**2015-2017 ICC CODE DEVELOPMENT CYCLE
UPDATES TO THE 2016 REPORT OF THE COMMITTEE
ACTION HEARINGS
TO THE INTERNATIONAL CODES
GROUP B**

Updated 7/28/2016

The following is a compilation of errata discovered since the posting of the Report of the Committee Action Hearing results on June 1, 2016

FIGURER403.4 (2)

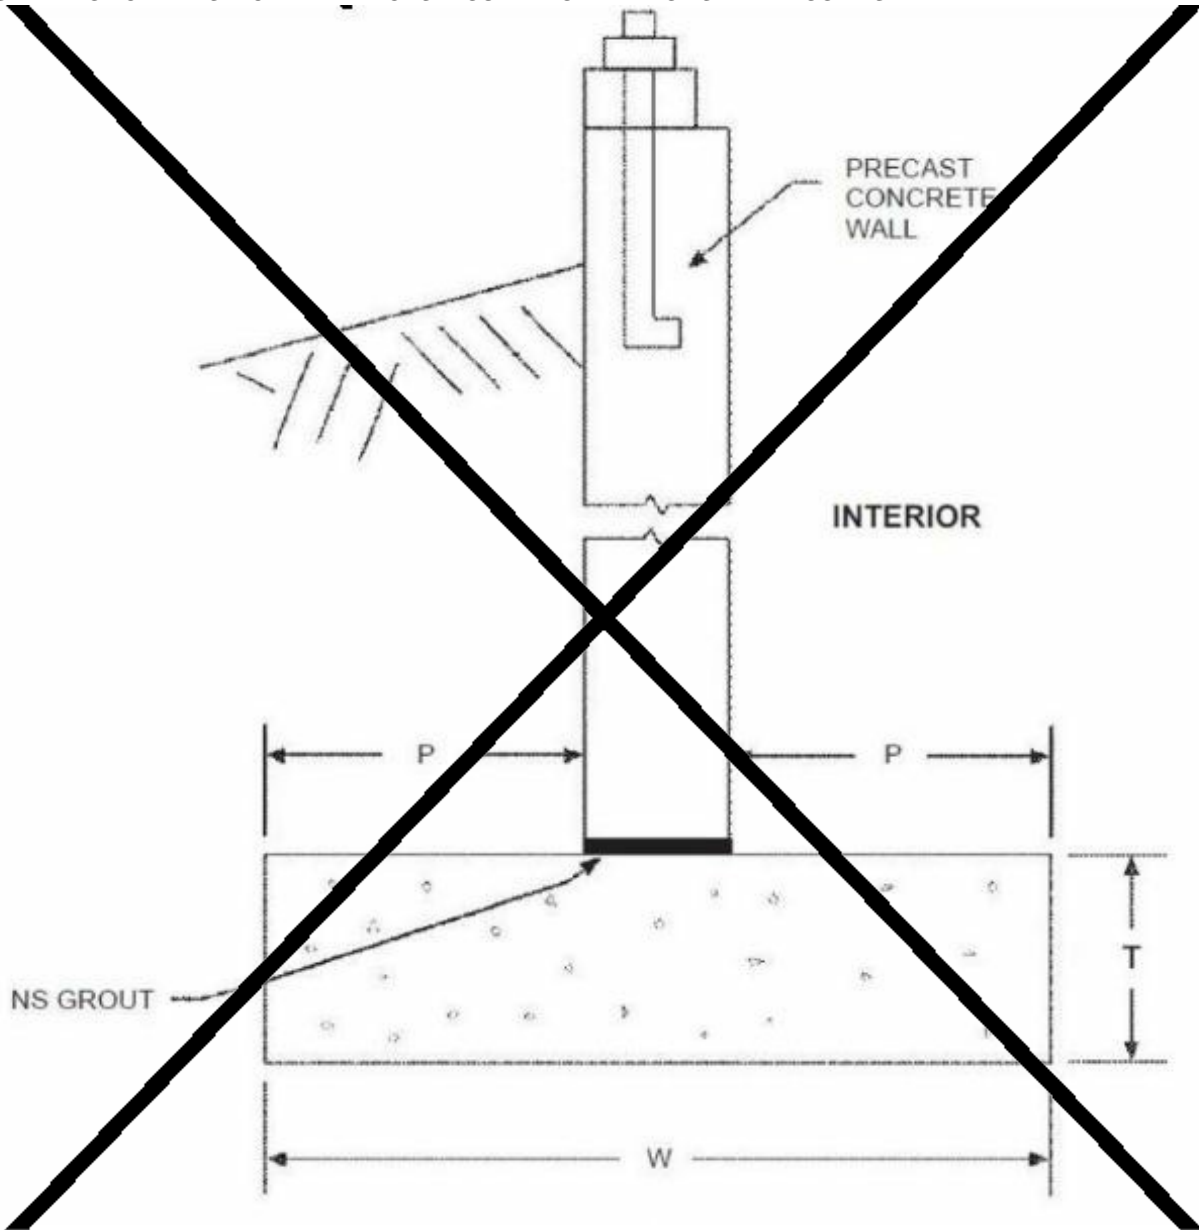
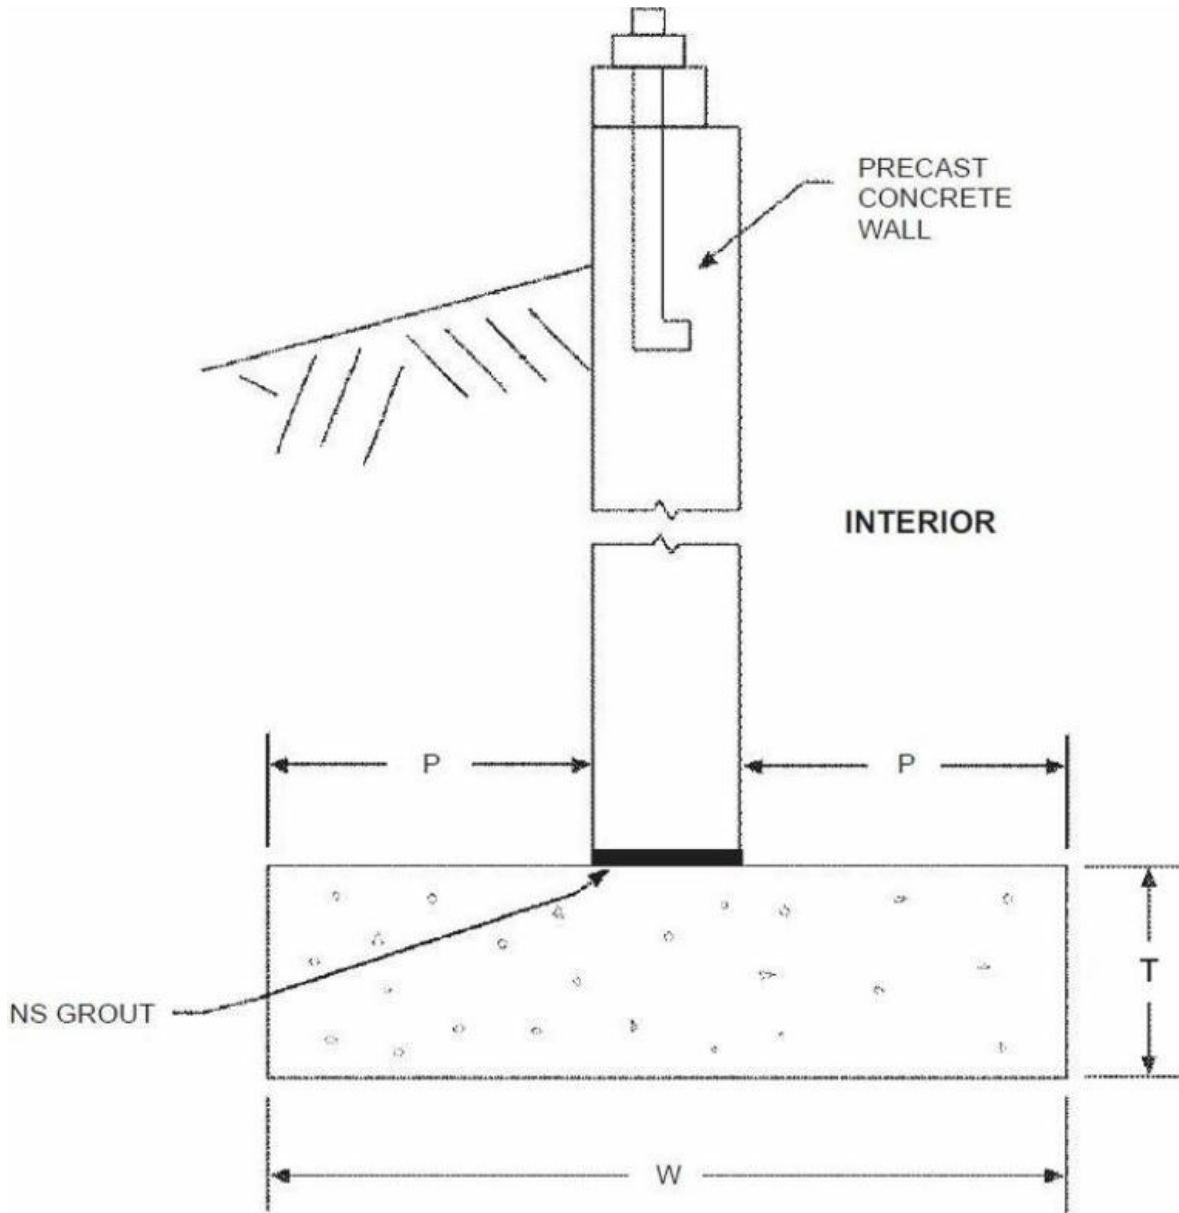
Committee Reason: This proposal updates the figure to add the dimension T for the footing thickness. The modification reverts the figure to the original with dimension T added. The proposed figure was too restrictive.

FIGURE R610.5 (4)
SIP WALL-TO-WALL PLATFORM FRAME CONNECTION

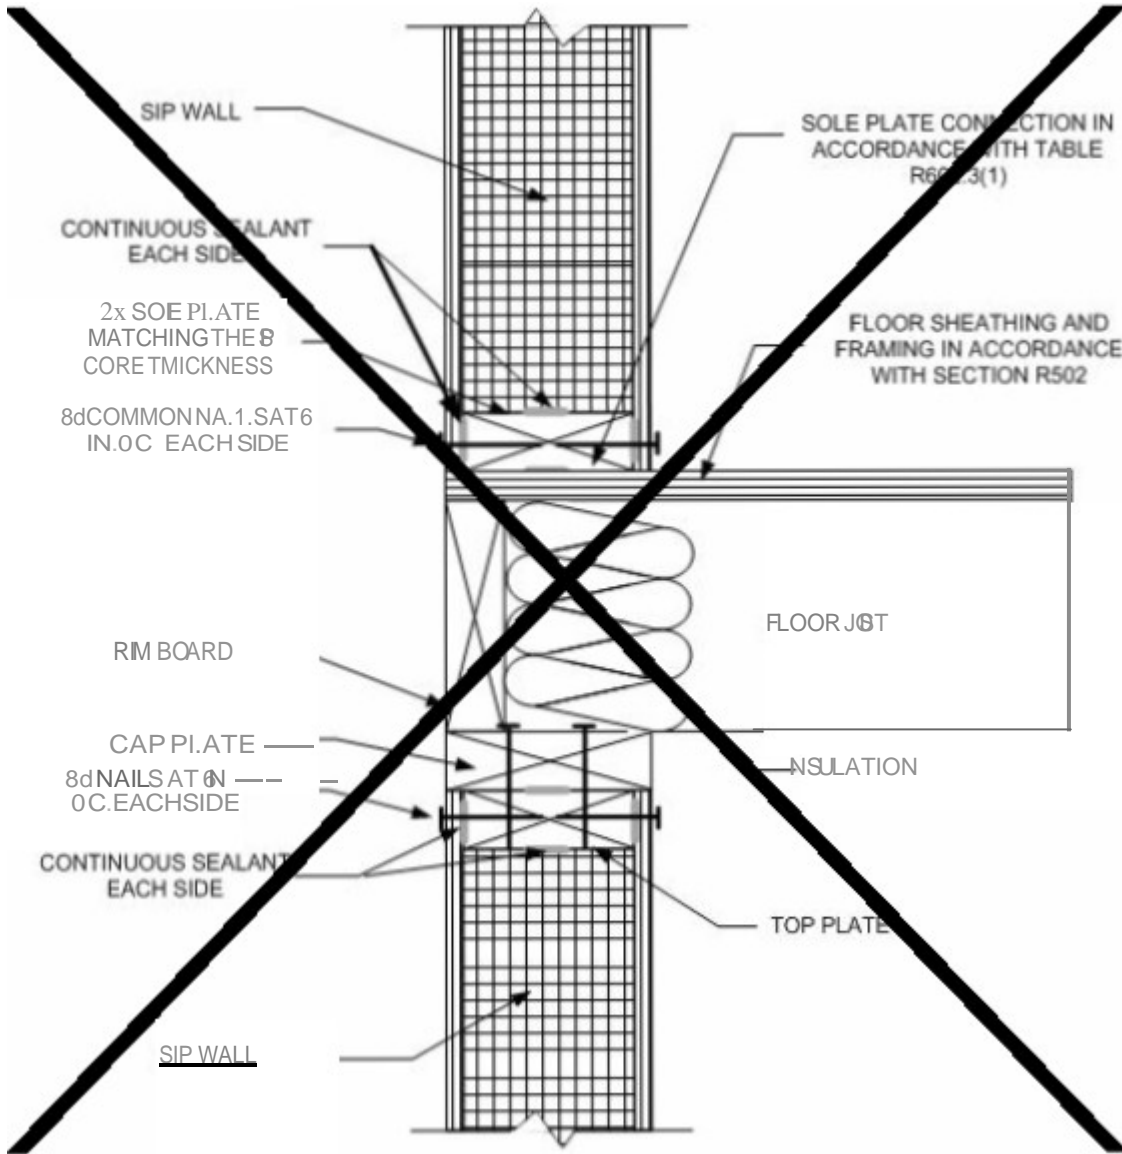
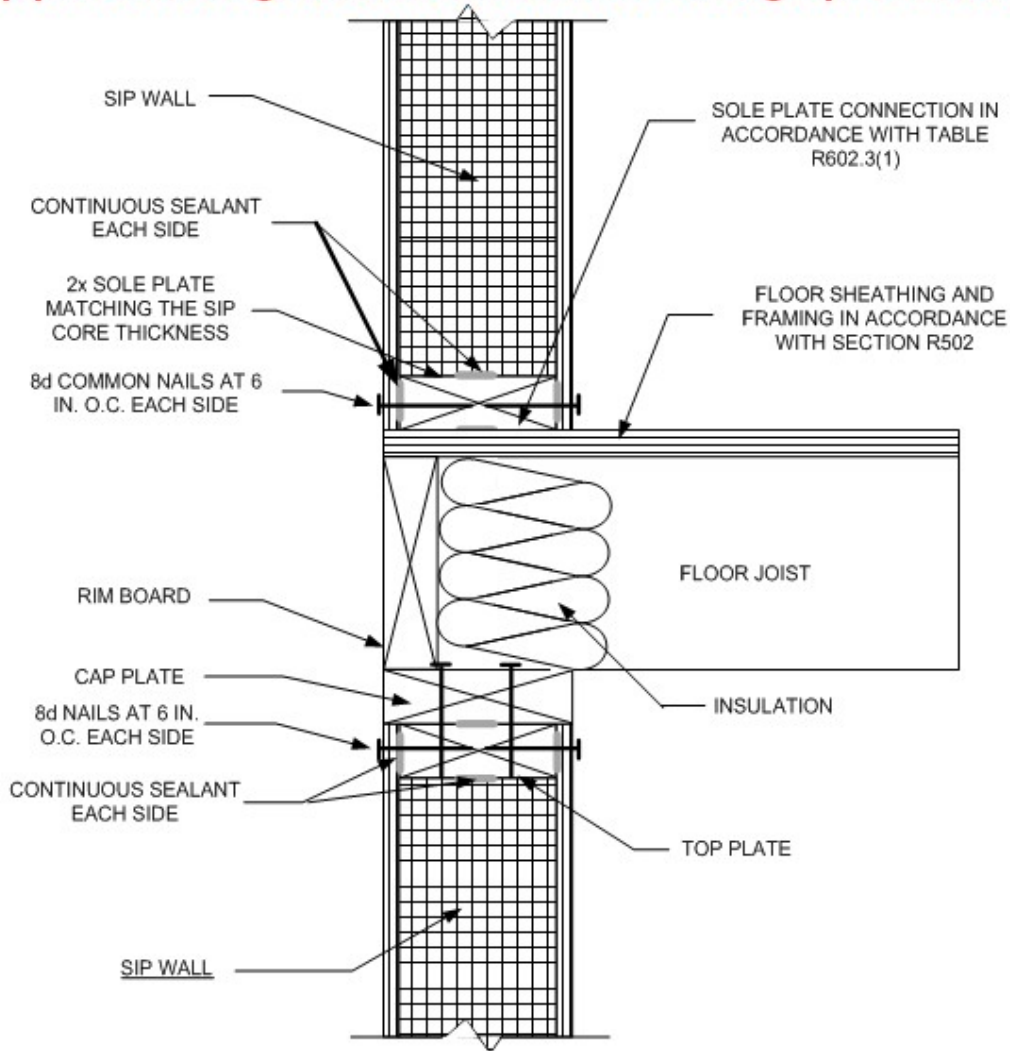
Committee Reason: The committee approved the proposal based on the proponents published reason statement. The proposal adds a new standard and clarifies and cleans up several sections of the SIPS requirements. The modification corrects several errors that occurred during the proposal submittal process.
